PSL Frequency Stabilization

Frequency Stabilization Servo Rev. F

Title: *Frequency Stabilization Servo*
Size: D Number D980536-F-C Revision: F
File: Date: Oct 1, 2001 Time: Sheet of
LIGO Laboratory, California Institute of Technology, Massachusetts Institute of Technology
Engineer: *Richard Abbott*
LIGO

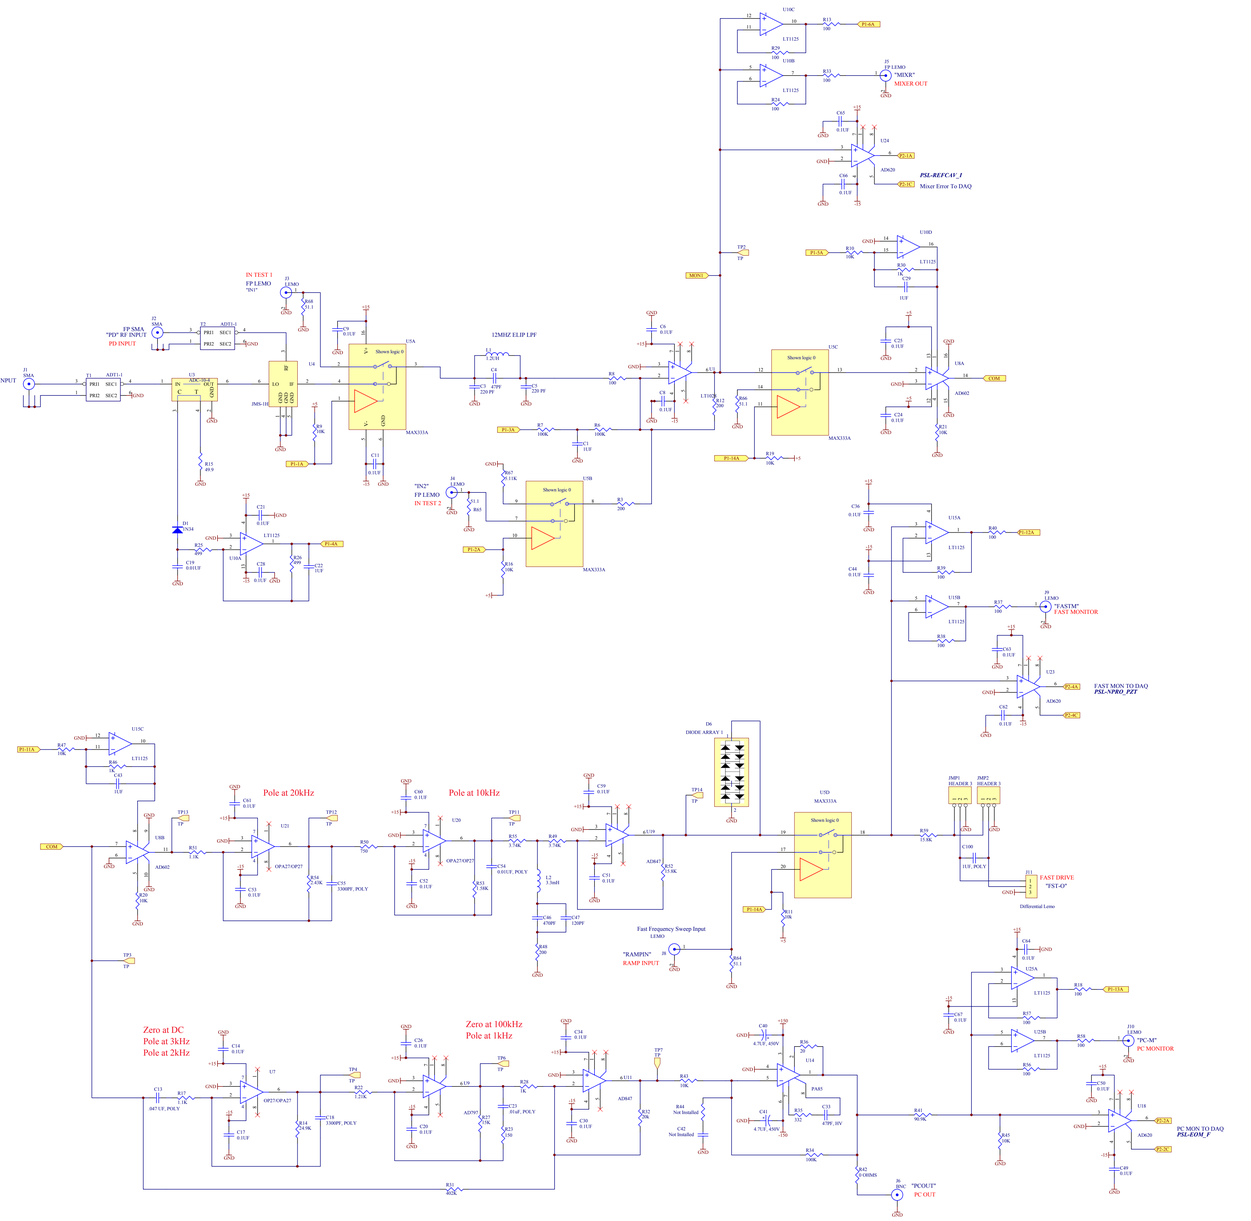
Change Summary for Rev E & Rev F Boards

REV E UPDATES...

*** U7 was an LT1028 and is now an OPA27**

*** R31 has been changed from 100K to 402K**

*** The capacitor in parallel with R52 across U9 has been eliminated from this schematic**

*** R44 and C42 are not installed**

*** C16 formerly in series with C18 has been shorted out.**

*** 1ufd External Cap in the Fast Drive area has now been formally designated C100**

REV F UPDATES...

*** 51 ohm resistors added from the following points to ground: J4-1, U5-14, J3-1, J8-1**

***5.11K added from U5-9 to ground**
